RE: GRADING AND DRAINAGE PLAN FOR MT. CARMEL TRAILER PARK, TRACT 5B, MRGCD
MAP 39, (K12/D23)(PWD-96-177) ENGINEER'S STAMP DATE 9/26/96.

GRADING AND DRAINAGE PLAN

MOUNT CARMEL MOBILE HOME PARK

TYPICAL LAND TREATMENT

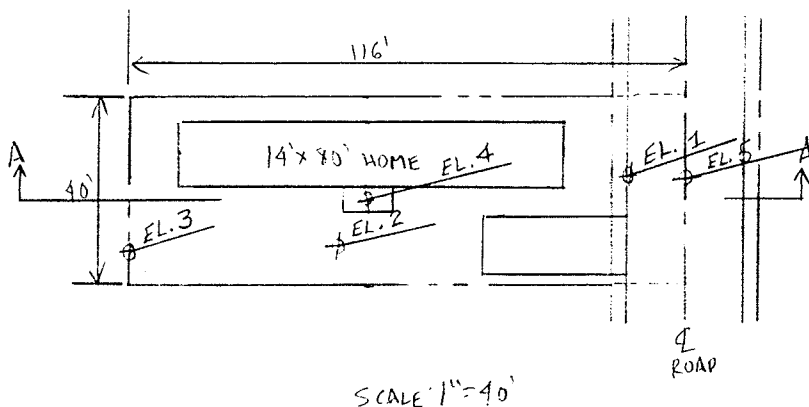
*does this account for
1/2 road adjacent
to lot? OK*
